Addendum

Re: Addendum No. 3 to specifications SU-112514,
Answers to bidder's questions & drawing clarification

Project Title	SUNY PURCHASE DIMMER ROOMS		
Drawing Title	MECHANICAL / ELECTRICAL INSTALLATION PART PLANS		
Scale	AS NOTED	Drawing No.	ME - 100.00
Date	7/30/2014	C.E. Job No.	
Drawn		Copyright c 2003 by Collard Engineering, G.C.	
Checked

INSTALLATION PLAN - DIMMER ROOM D

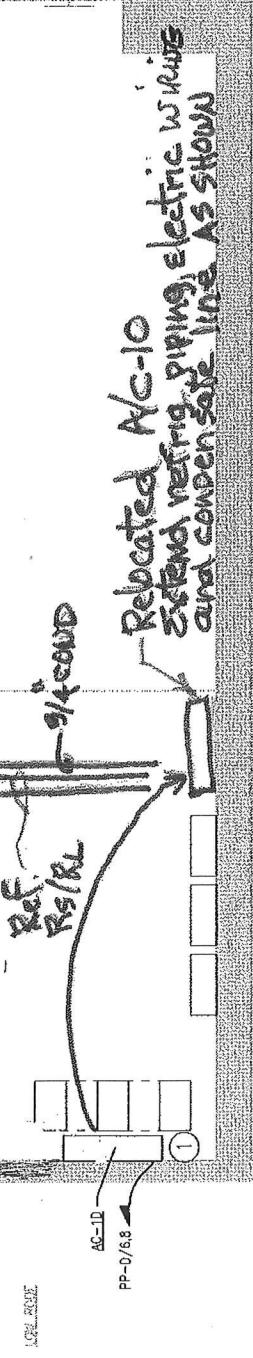
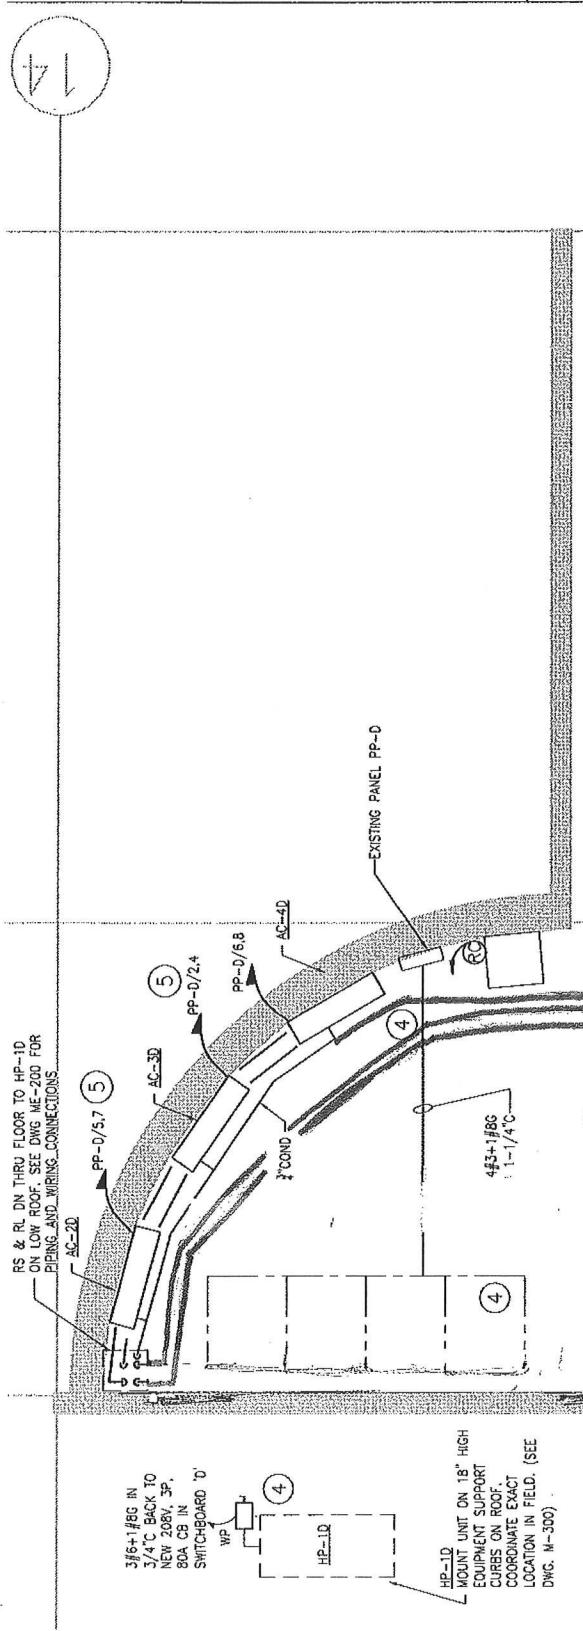
Clarification for Dimmer Room D:

Relocate AC-10 from wall behind dimmer switches to adjacent west wall next to the 3 existing switch panels. Extend the refrigeration lines and $\frac{3}{4}$ " condensate line to the new location. Do not run any piping above any existing electrical equipment. Please see the attached sketch.
